IMPORTANT: New Switch Design

The round product select button has undergone a design revision to improve durability in high-use environments.

752-599
12/09

The new switch has locking posts.

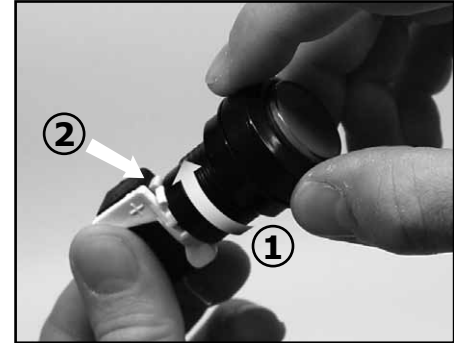
Previous versions of the product select button used a “snap in” method of connecting the white plastic switch bracket to the black switch body. The new design features a bayonet-style connection method, similar to that found on BNC connectors.

IMPORTANT: New revision and old revision switch components are not compatible. Do not attempt to use differing parts together. The two components will not mate together – forcing the connection risks damage to the switch.

Two posts on the switch bracket must be aligned with the receptacles inside the switch body, pushed together, then twisted to lock into place.

To mate switch parts, insert switch as shown and twist clockwise (1) so that push button foot meets the switch actuator (2).

To remove the switch mechanism from switch body, turn a few degrees counter clockwise, and pull apart.
